Intersection ID: 11357	Main Street: W_TRADE_ST	Cross Street: N_IRWIN_AV	Location:	N
ADA ID: A198E522B97C	Ramp Type: Perp	Initial Pass/Fail: Fail	Overall Compliance: No	Severity Score: 13.75

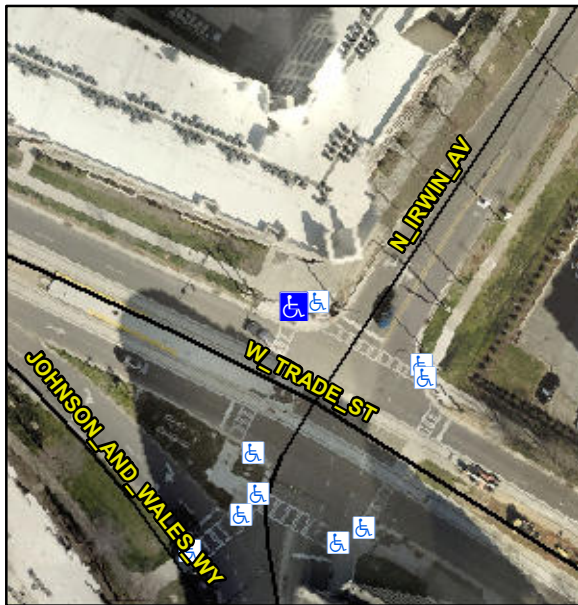
R304.2.2

Compliance	Description	Data	Compliance	Description	Data
N/A	Ramp Length (in)	74.0	No	Ramp Slope (%)	9.7
Yes	Ramp Width (in)	58.0	Yes	Ramp XSlope (%)	3.6
N/A	Flare Type LT	N/A	N/A	Flare Type RT	N/A
N/A	Flare Slope LT (%)	N/A	N/A	Flare Slope RT (%)	N/A
N/A	Flare Traversable LT?	N/A	N/A	Flare Traversable RT?	N/A
N/A	Landing Length (in)	N/A	N/A	DWS Provided?	N/A
N/A	Landing Width (in)	N/A	N/A	DWS Contrast?	N/A
N/A	Landing Slope (%)	N/A	N/A	DWS Length (in)	N/A
N/A	Landing X Slope (%)	N/A	N/A	DWS Full Width?	N/A
N/A	Landing Curb? (Y/N)	N/A	N/A	DWS Offset (in)	N/A
N/A	Shared Landing?	N/A			
N/A	Gutter Ponding?	N/A	N/A	Gutter Slope (%)	N/A
N/A	Gutter Lip Ht (in)	N/A	N/A	Gutter X Slope (%)	N/A
N/A	Painted X Walk1?	Yes	N/A	Painted X Walk2?	N/A
	X Walk 1 Direction	To SW		X Walk 2 Direction	N/A
N/A	X Walk 1 Width (in)	83.0	N/A	X Walk 2 Width (in)	N/A
	X Walk 1 Slope (%)	1.6		X Walk 2 Slope (%)	N/A
	X Walk 1 X Slope (%)	4.7		X Walk 2 X Slope (%)	N/A

Remove & Replace Entire Ramp.
